HISTORIC AND DESIGN REVIEW COMMISSION

HDRC CASE NO: 2019-032
ADDRESS: 112 E PECAN ST
LEGAL DESCRIPTION: NCB: 139 LOT: 15 NATIONAL BANK SUB UNIT-2
ZONING: D, RIO-3
CITY COUNCIL DIST.: 1
APPLICANT: Elizabeth Parks/RVK Architects
OWNER: Santa Clara Land Company, LTD
TYPE OF WORK: Expansion of the existing parking structure
APPLICATION RECEIVED: April 12, 2019
60-DAY REVIEW: June 11, 2019
CASE MANAGER: Edward Hall

The applicant is requesting a Certificate of Appropriateness for approval to construct an addition of two levels to the existing parking structure. The proposed addition will feature an architectural cladding system.

A-901
3D PERSPECTIVES/
ISOMETRICS

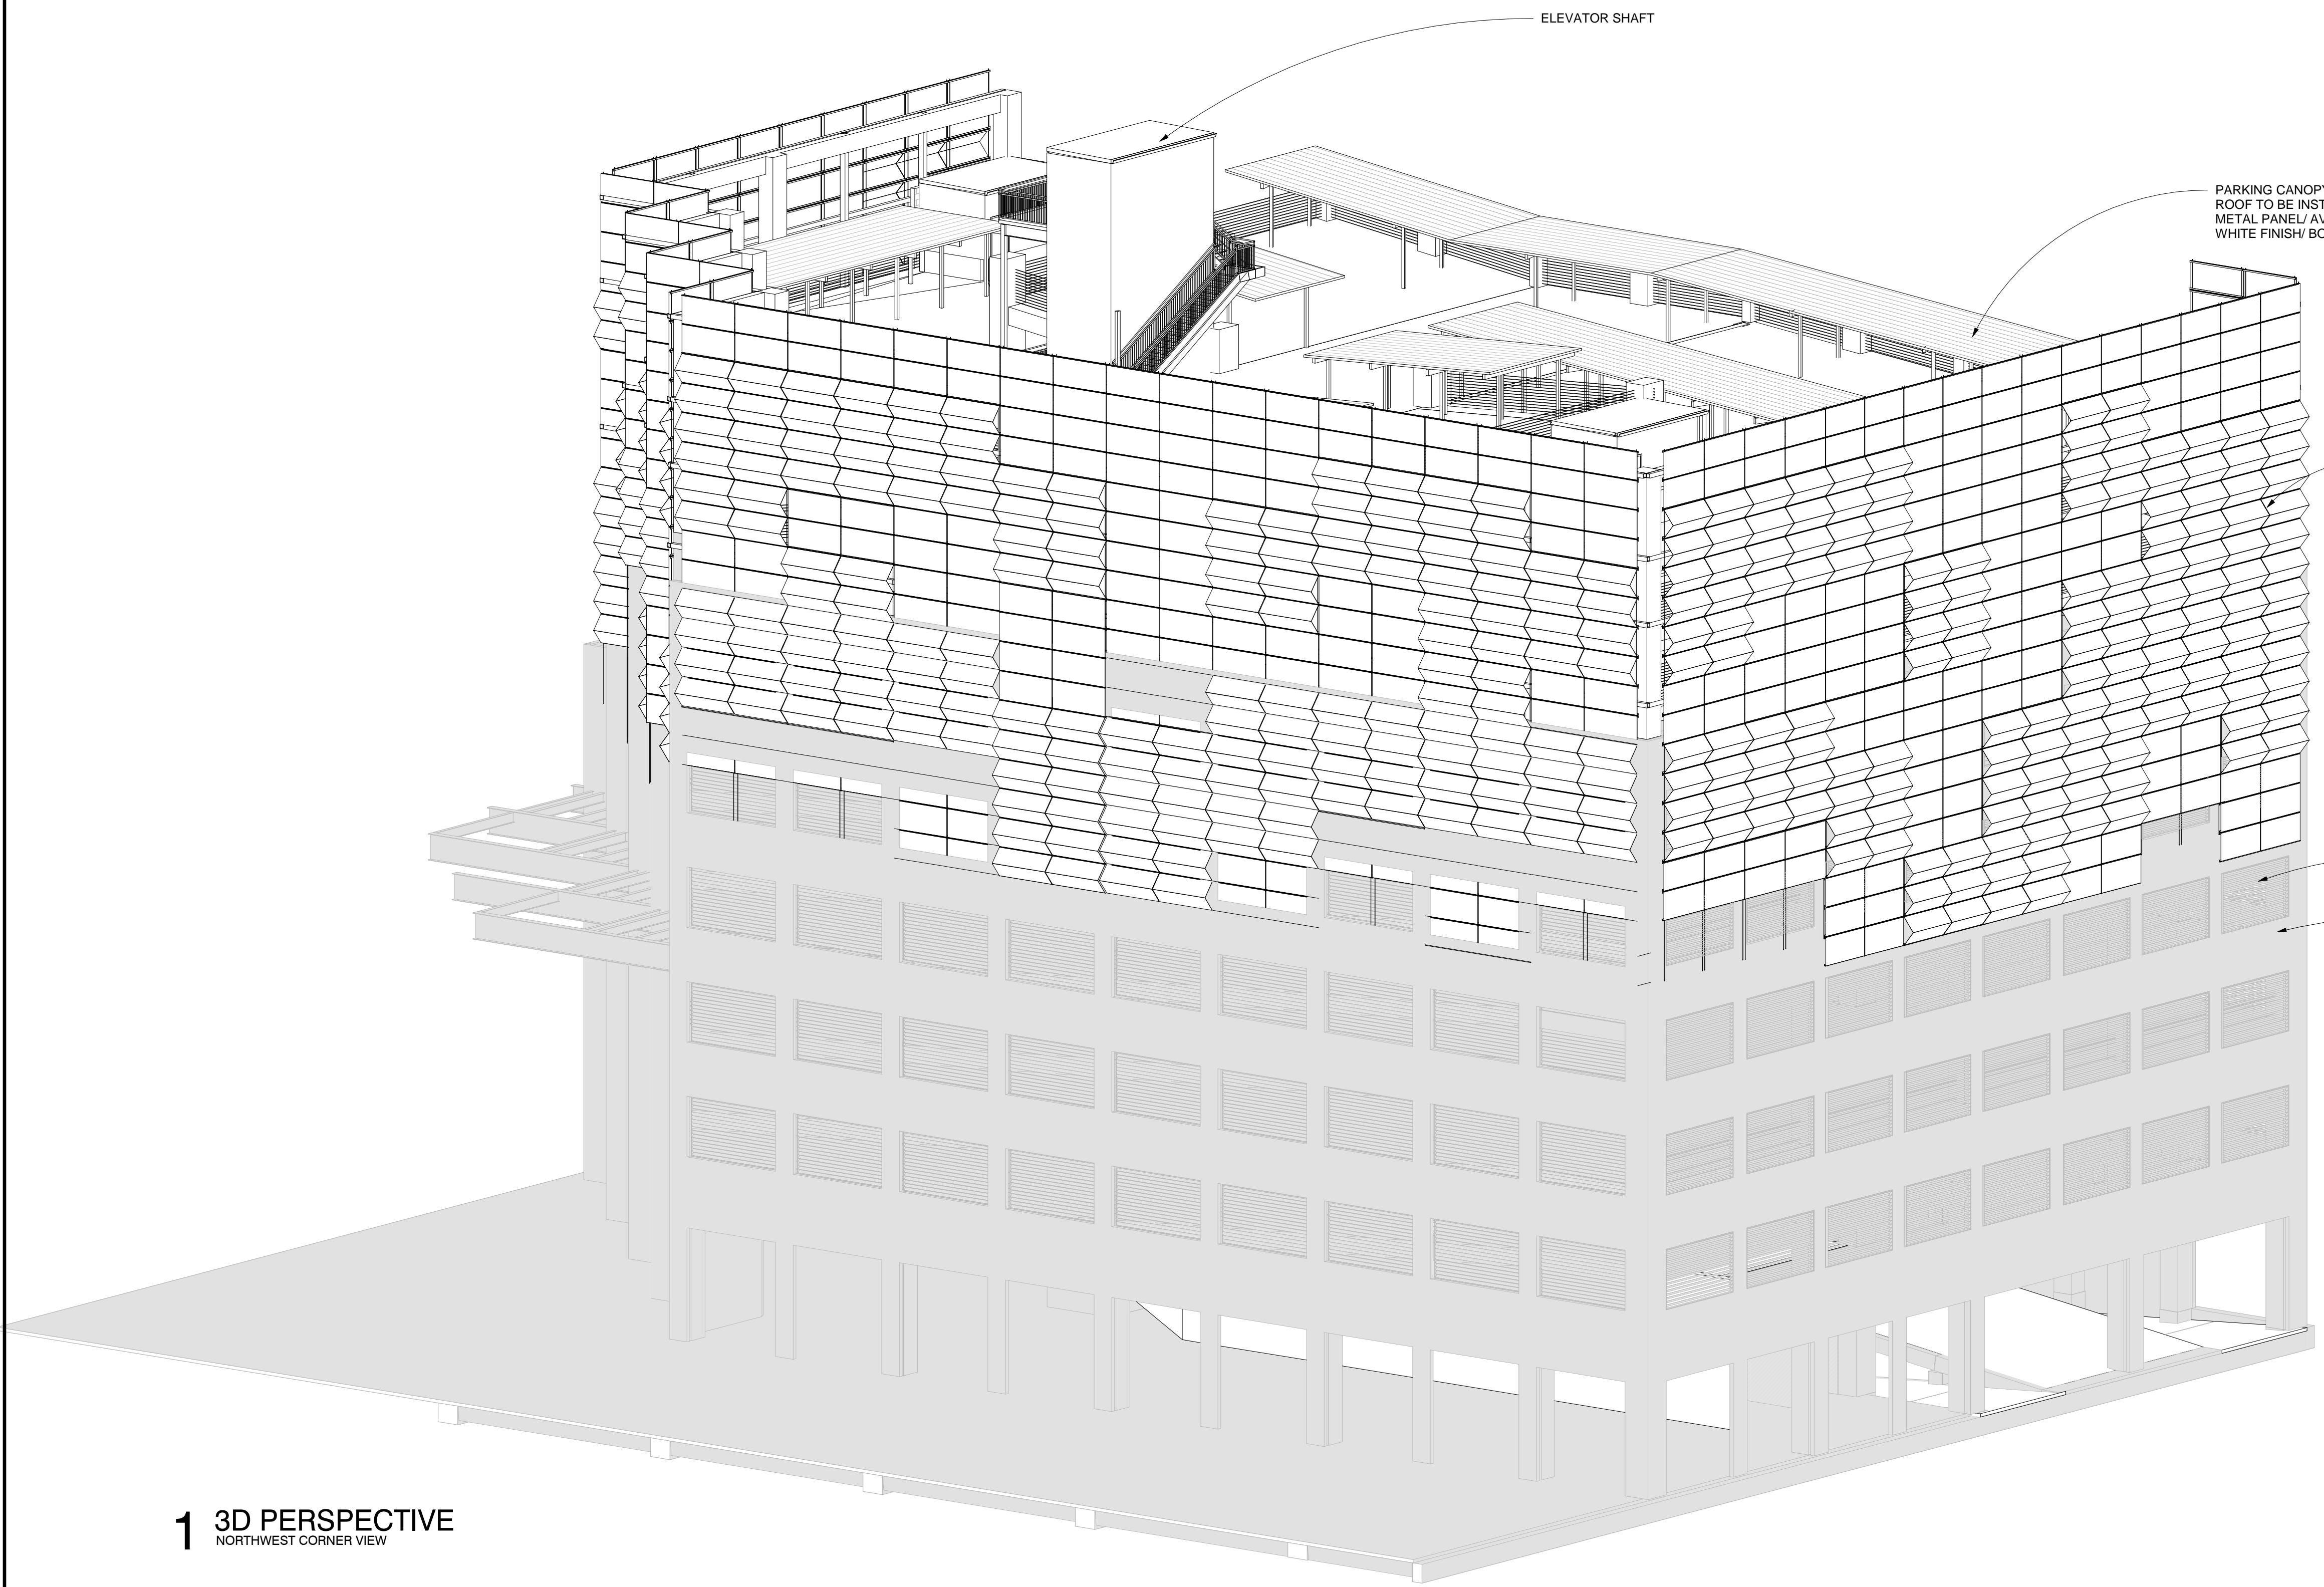
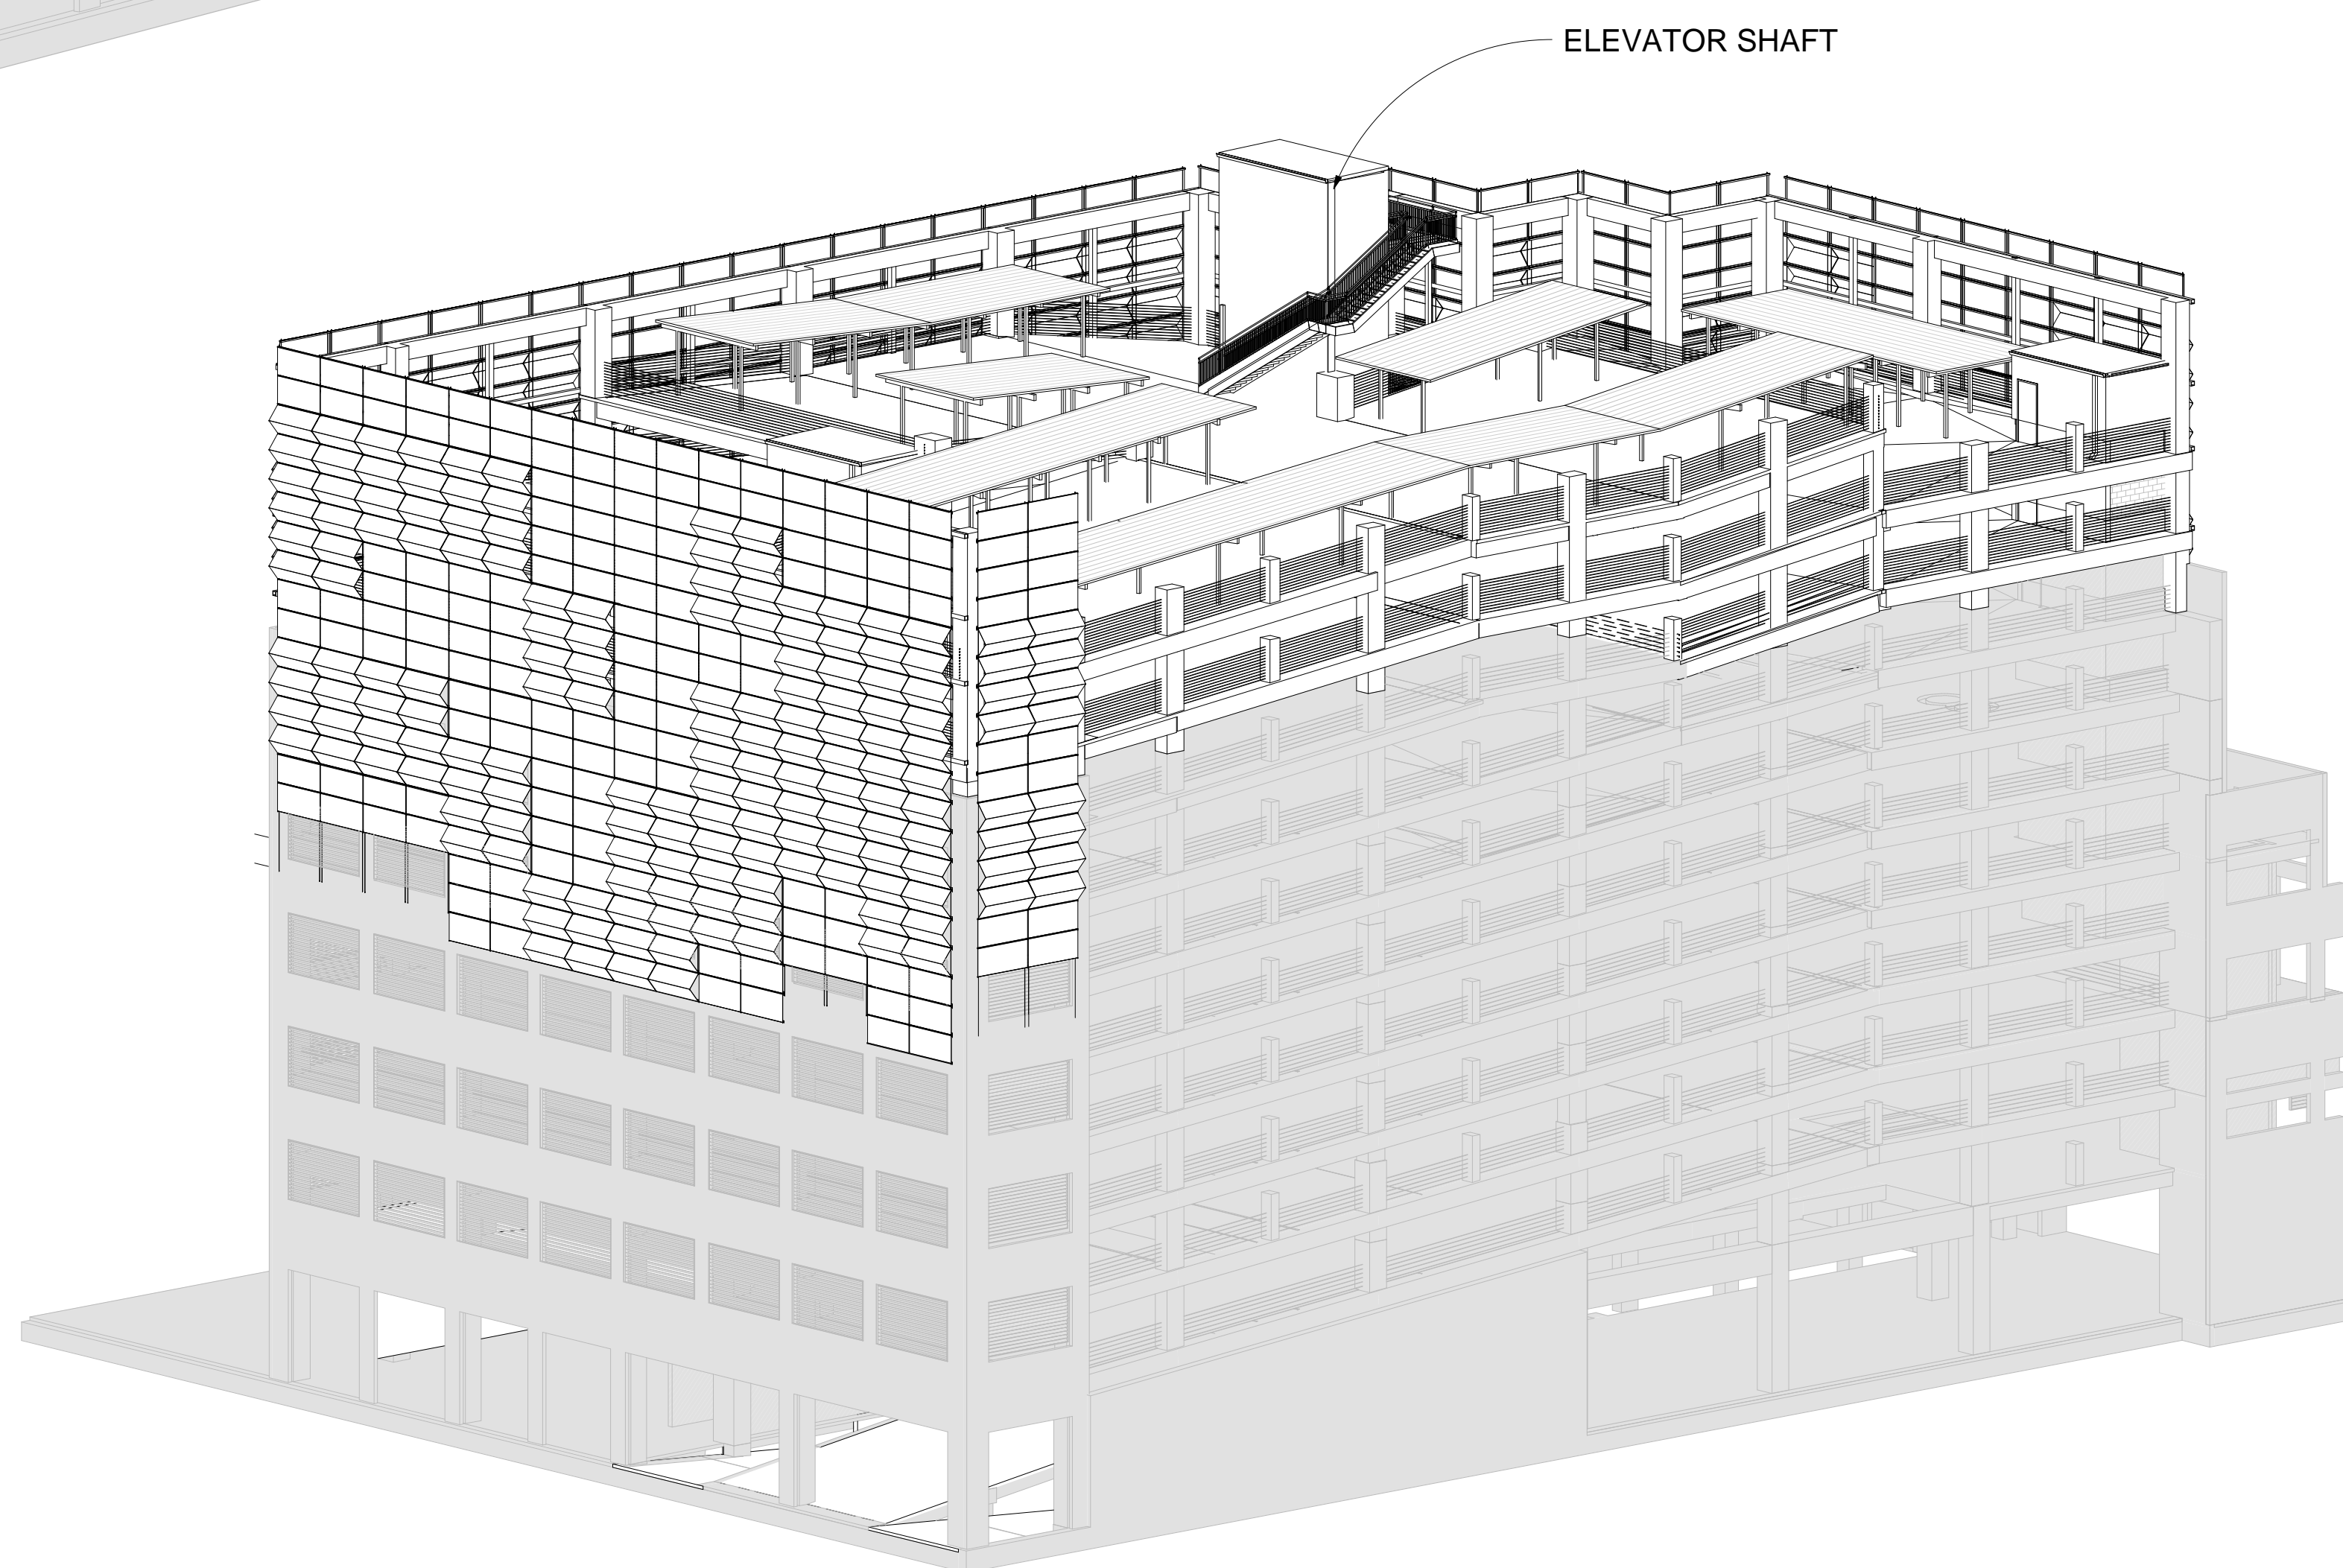
- e. GARAGE ADDITION – The UDC Section 35-672(b)(4) notes that parking structures shall be compatible with buildings in the surrounding area in the RIO. The UDC notes that parking structures are to not vary in height more than thirty (30) percent from another building on the same block face and use materials that can be found on other

buildings within the block. Additionally, parking structures are to be made visually appealing and should have retail space or office space on the ground floor. While the applicant has not proposed new ground level retail space, the existing structure features storefront system and colonnades at the street level. The proposed height and materials are consistent with this section of the UDC.

THERE WILL BE 2.63 FOOTCANDLES AT 20'-0" OFF THE FACE OF THE BUILDING.

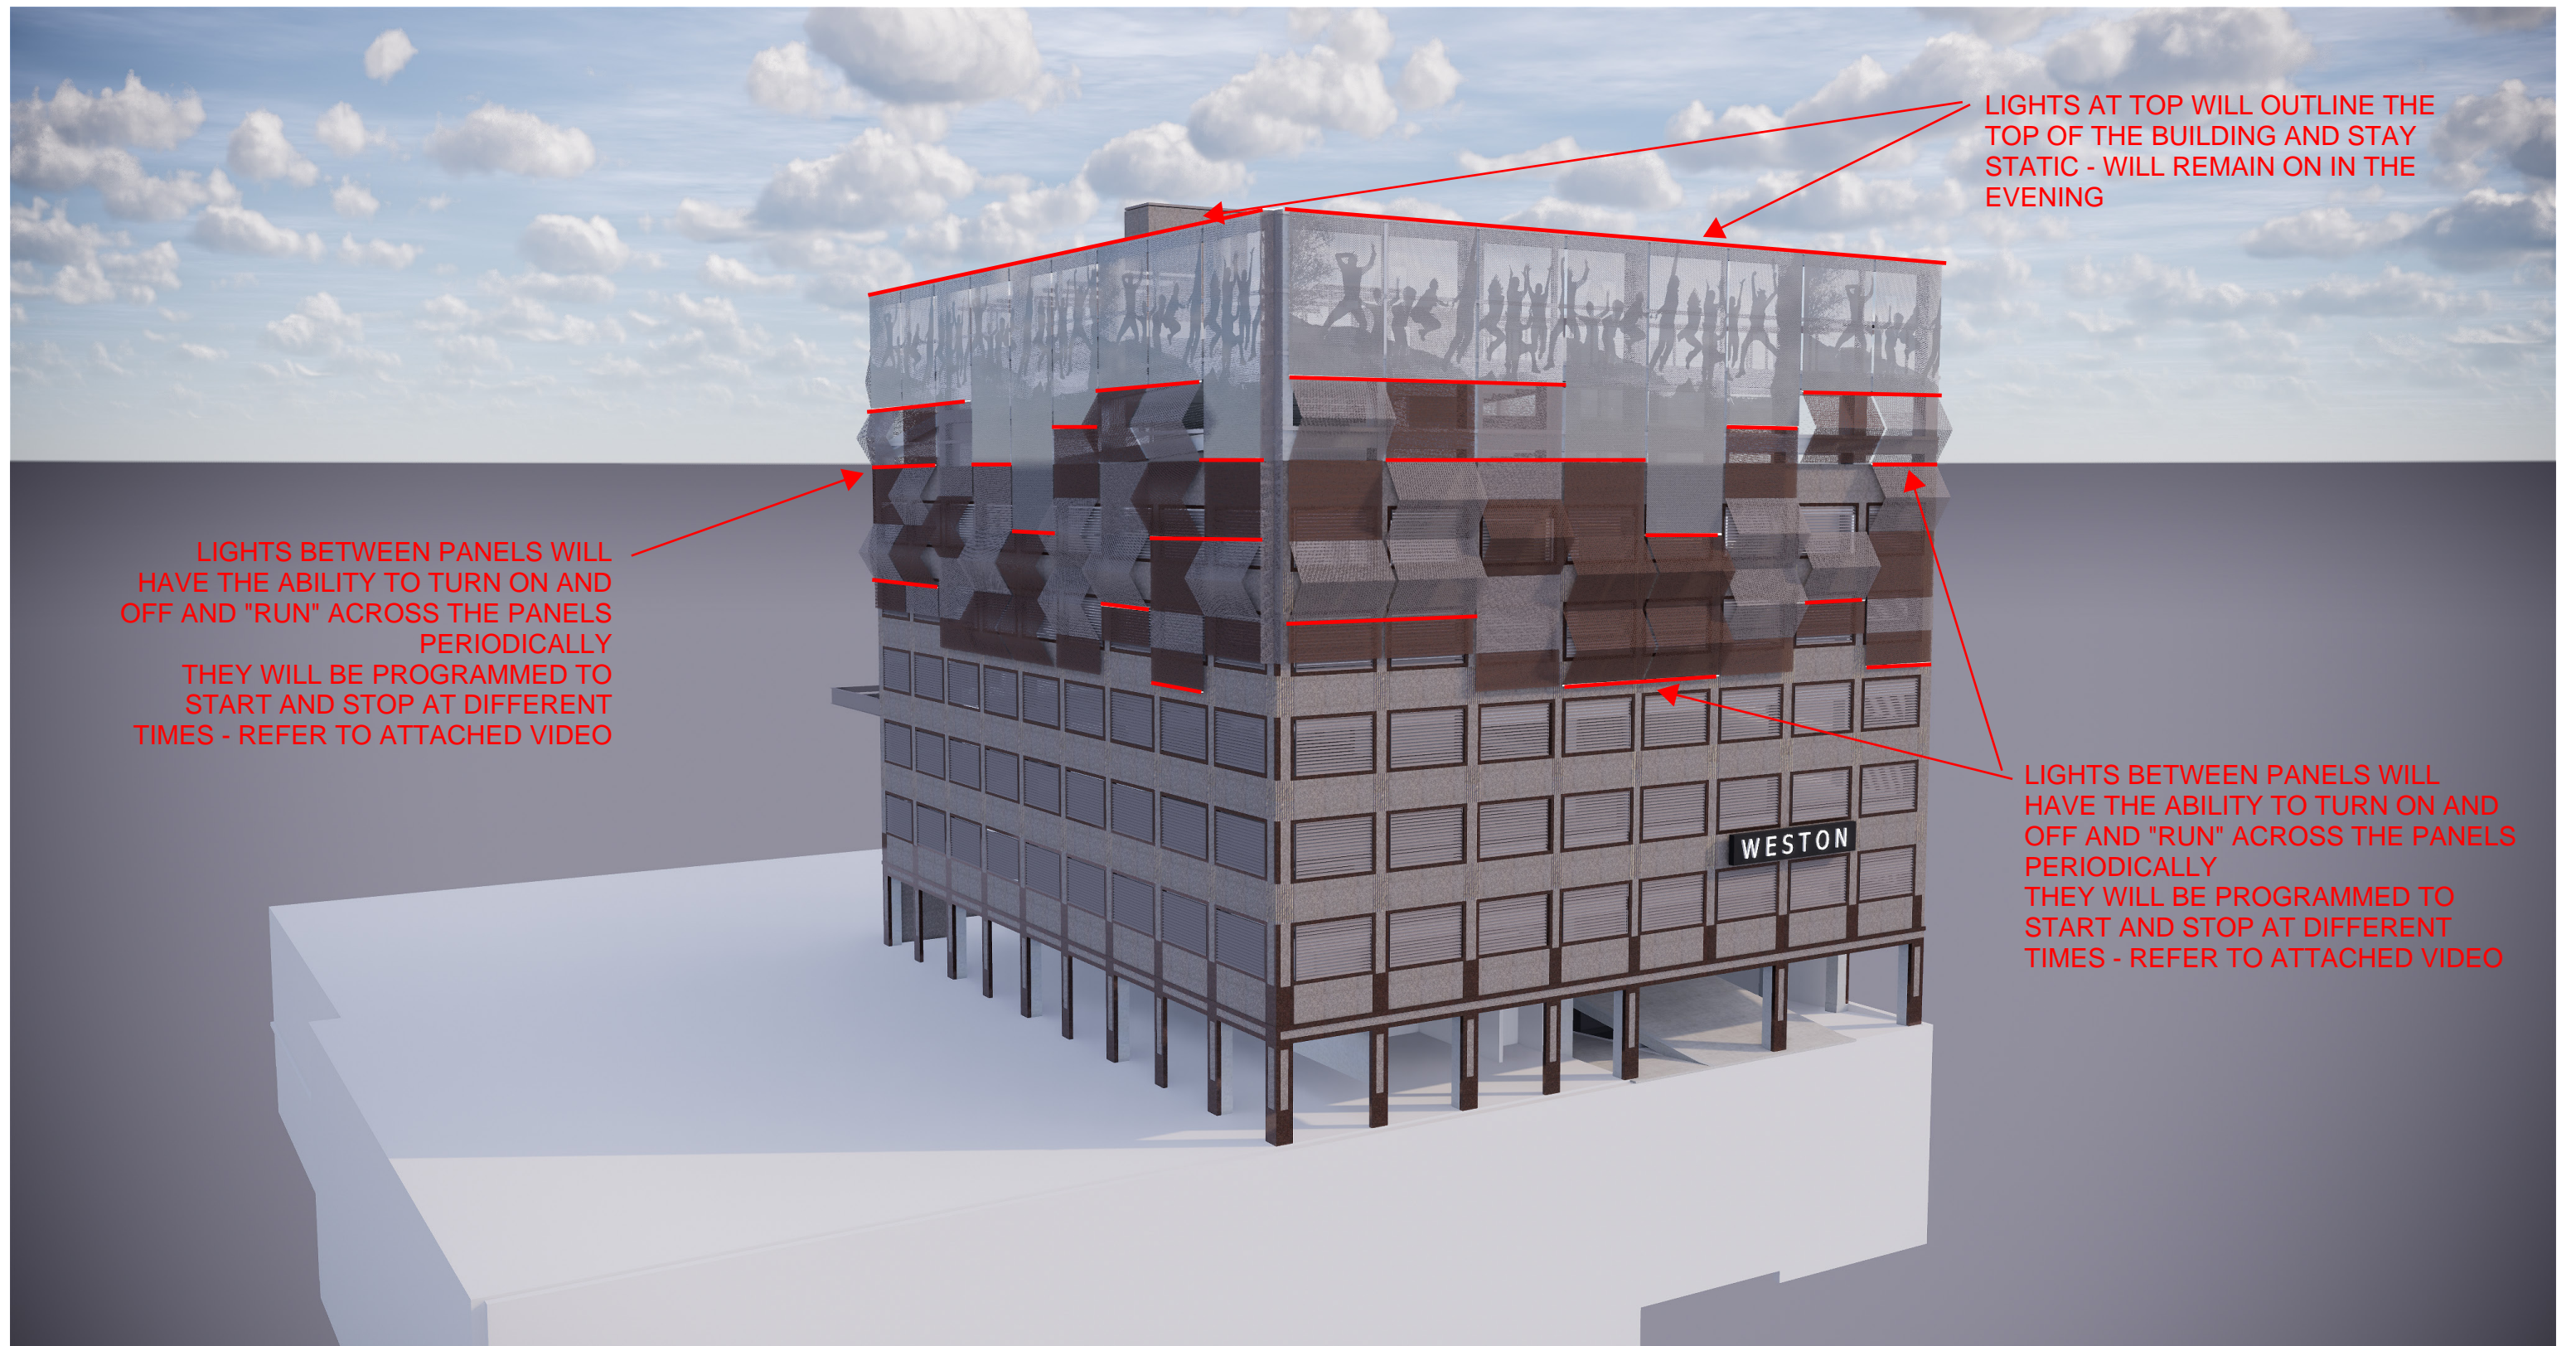
- i. That the applicant submit an architectural and site lighting plan when returning to the HDRC for final approval to ensure that light pollution is not a result of the proposed addition and new rooftop lighting.
The applicant has provided information regarding lighting and lighting fixtures.
